JABIRU AIRCRAFT PTY LTD

SERVICE BULLETIN: JSB 012-5

Issue: 5

Subject: Jabiru Engine Flywheel Attachment

Figure 2 - Plain washers compared to Nordloc washers

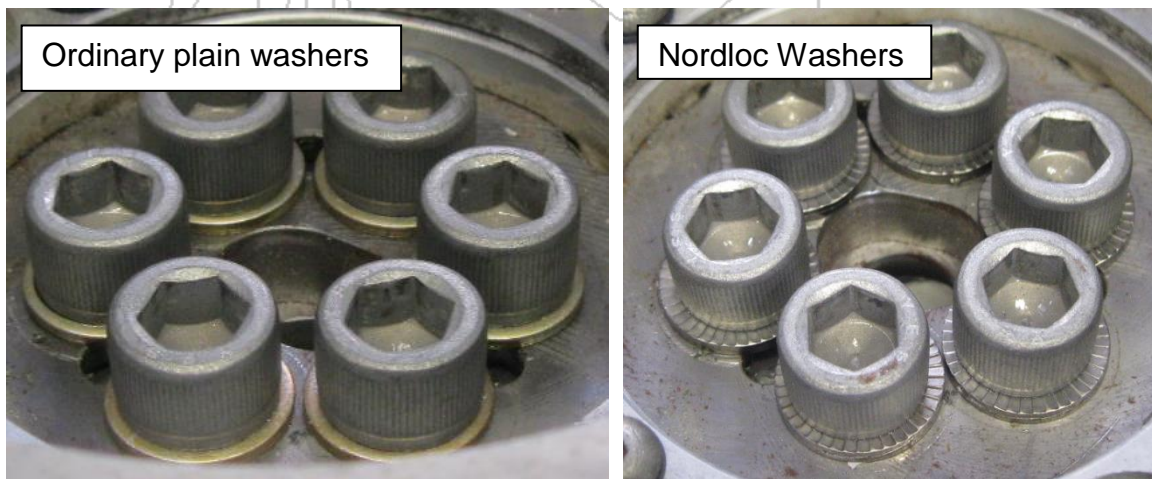
Flywheel screws must now be installed using Nordloc washers (replacing the previous installation which used either plain or Belleville washers). Jabiru engines of any and all flywheel configurations (as defined in Table 1) should now use Nordloc washers. These washers are easily identified via visual inspection as shown below in Figure 2.

Refer to the Jabiru Engine overhaul manual JEM0001 (always check for the latest revision) for the installation procedure of flywheel capscrews using Nordloc washers. The major difference in installation is that bolts installed with Nordloc washers **must not be installed with Loctite**. The torque setting is also different for capscrews installed with these washers.

When Nordloc washers are used on an aluminium surface a steel plate must be used to protect the aluminium surface. These are available from Jabiru.

- As previously stated Loctite 620 MUST NOT be used on flywheel attachment bolts installed with Nordloc washers.
- Removing bolts which have been retained with Loctite 620 can normally be achieved by heating the bolt to over 150°C using a pencil-point gas burner. Minimise direct heat applied to the head of the screw as this can weaken the drive socket – direct heat towards the thread as much as possible.
